## **APPENDIX 4 - BECA – RURAL INTERFACE REVIEW**

**To:** Hayley Thomas and Peter Skilton  
**From:** Ben Frost  
**Copy:** :  
**Subject:** PC14 Landscape Interface Review  
**Date:** 14 November 2024  
**Our Ref:** 4671856-563438831-259

Figure 3: Proposed Mangaone Precinct Structure Plan

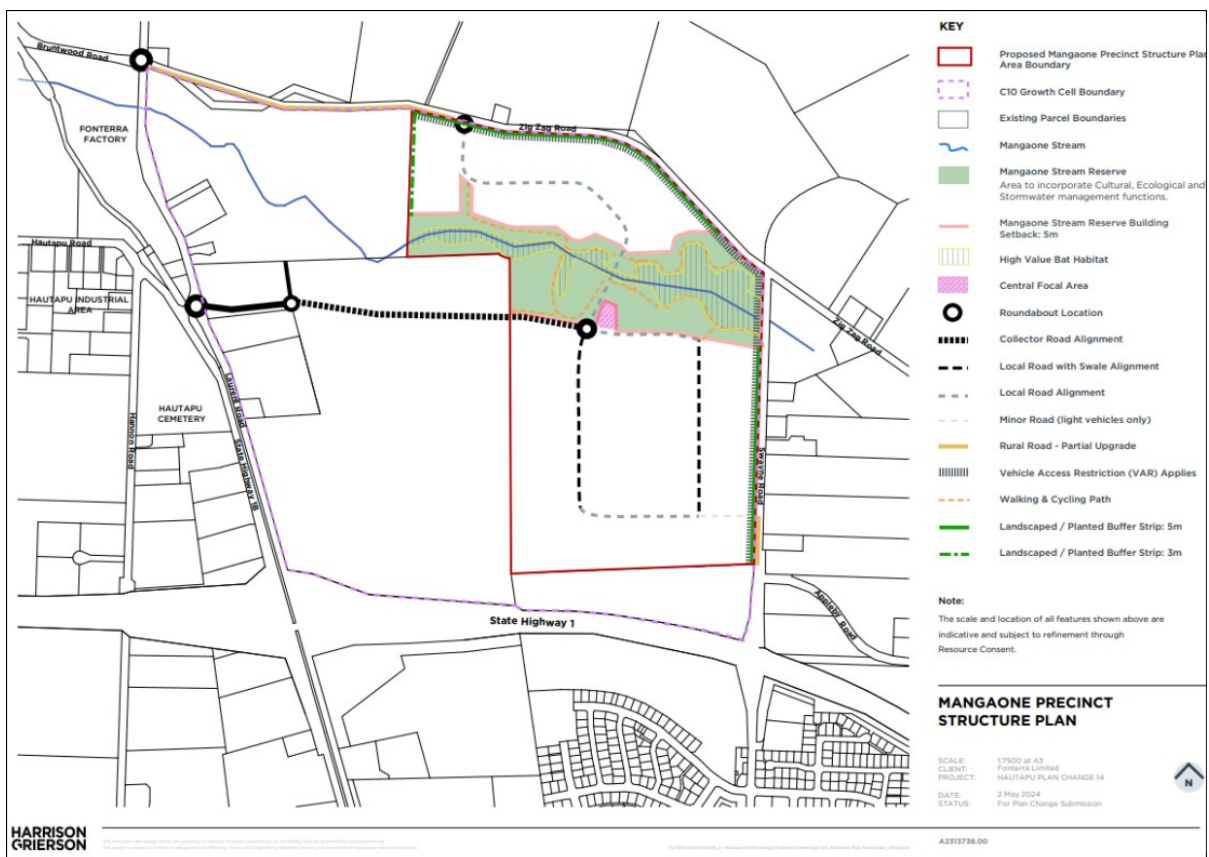
Of particular relevance to this review is the provision of a 5m landscape buffer and Vehicle Access Restriction (VAR) along the Swayne Road and Zigzag Road frontages. Of note is that the Kiwifruit Block to the south of the Mangaone Precinct is not included in the Structure Plan. The Assessment of Environmental Effects (AEE) describes this area as *“has now been largely developed and/or consented for industrial purposes (i.e. for stormwater management purposes and a maintenance facility) in conjunction with existing and proposed activities within the Bardowie Industrial Precinct”*. Consequently, the proposed landscape and VAR is not shown over this portion of land.

Figure 4: Building setback adjoining Swayne or Zig Zag Road

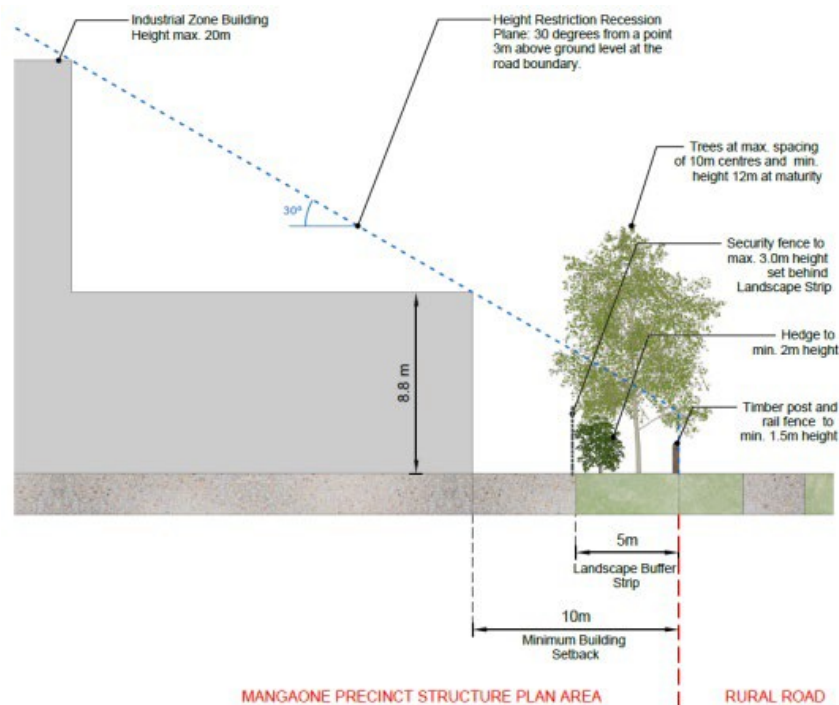
While the rules relating to building height, setback, and recession plane are separate it is helpful to consider them together for the purpose of this review. Using the scenario in Figure 4 above, a 10m

setback and recession plane of 30 degrees 3m above ground at the boundary yields an 8.8m high building 10m from the boundary. Using the same recession plane the 20m (max) building would be setback by 29.5m.

Provided the landscape buffer recommendations can be satisfied, it is considered a 10m minimum setback for building is a suitable outcome for this context. While a 15m setback appears to be consistent with other industrial / rural residential interfaces in the Waipā District, this often occurs adjacent to State highways or building frontage or where the scale of landscape planting is substantially smaller than that proposed as part of PC14. Ultimately the scale of building at a 10m or 15m setback is proportional to the recession plan rules. A 15m setback or more maybe more appropriate where planting cannot be adequately accommodated to mitigate effects.
